# ***Menangle Sand and Soil Quarry***

*Section 75W Modification  
Assessment  
(DA 85/2865 MOD 1)*

October 2018

**Figure 3** | Proposed Stage 8 area

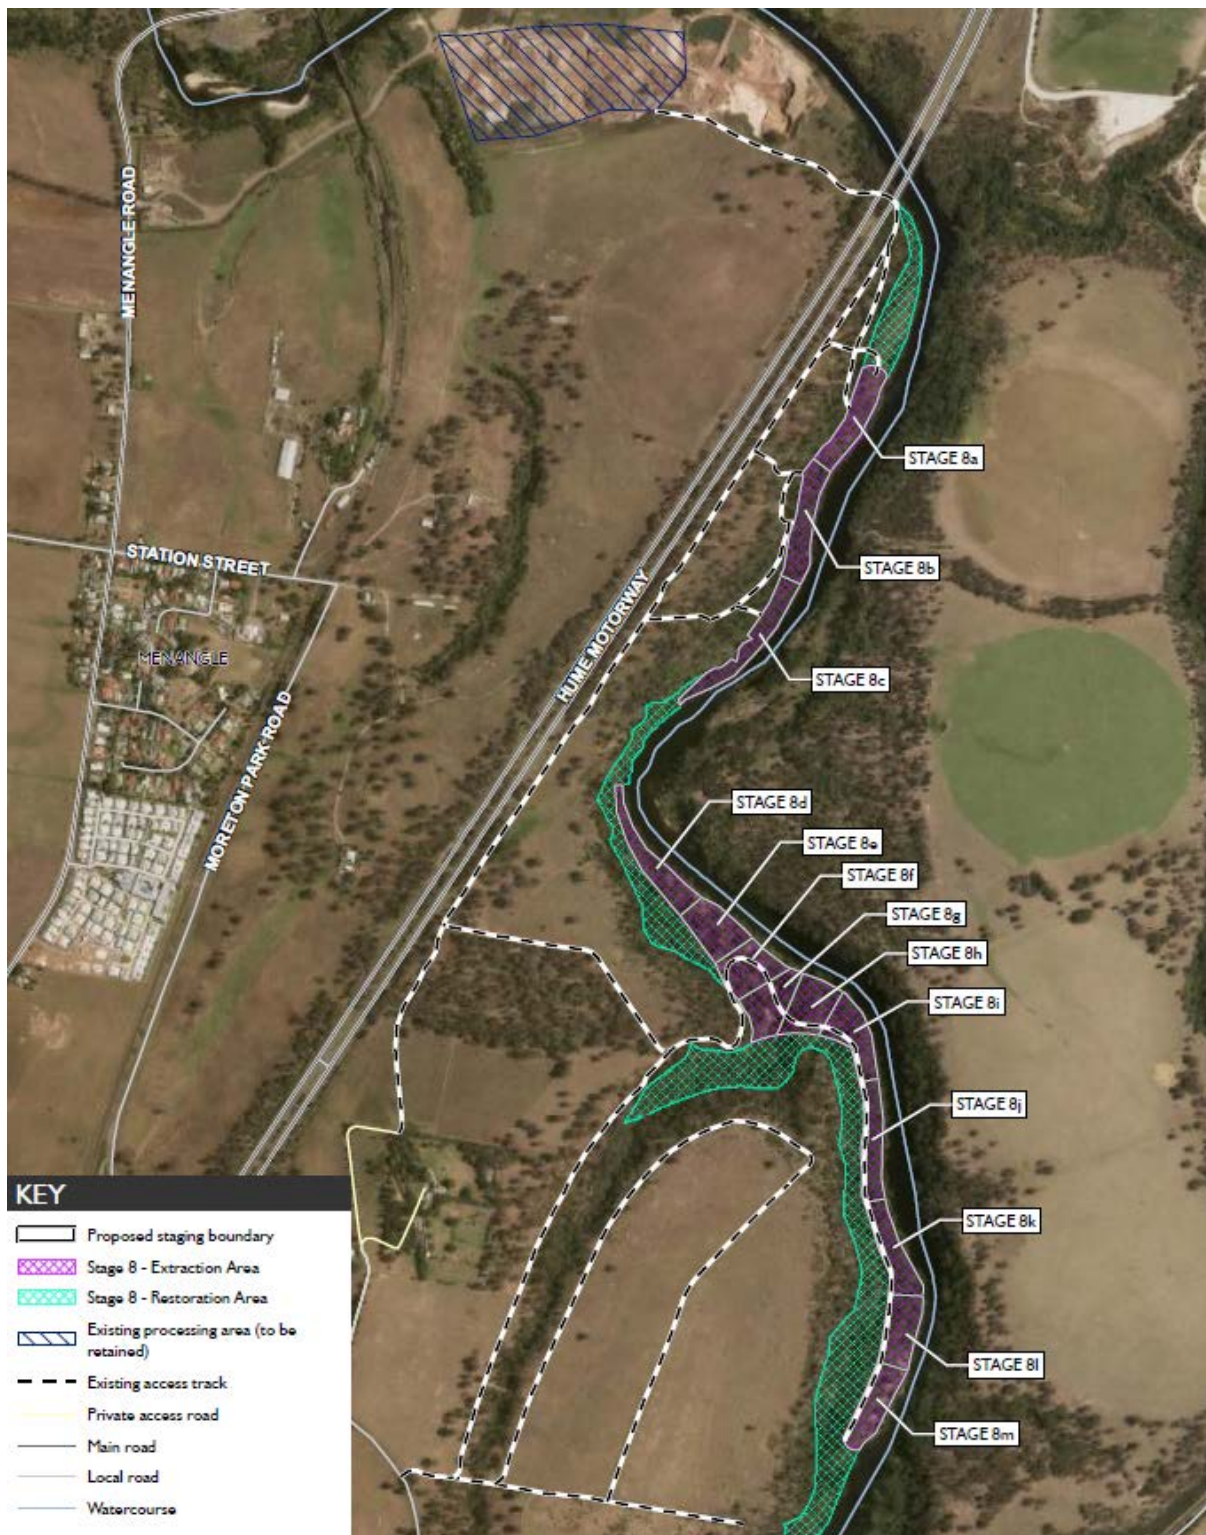
- stage 8J (see **Figure 3**) to be in an excavated condition;
- all downstream stages (8A, 8B, 8C and 8I) to be in a rehabilitated state; and
- all remaining upstream stages to be in their existing state.
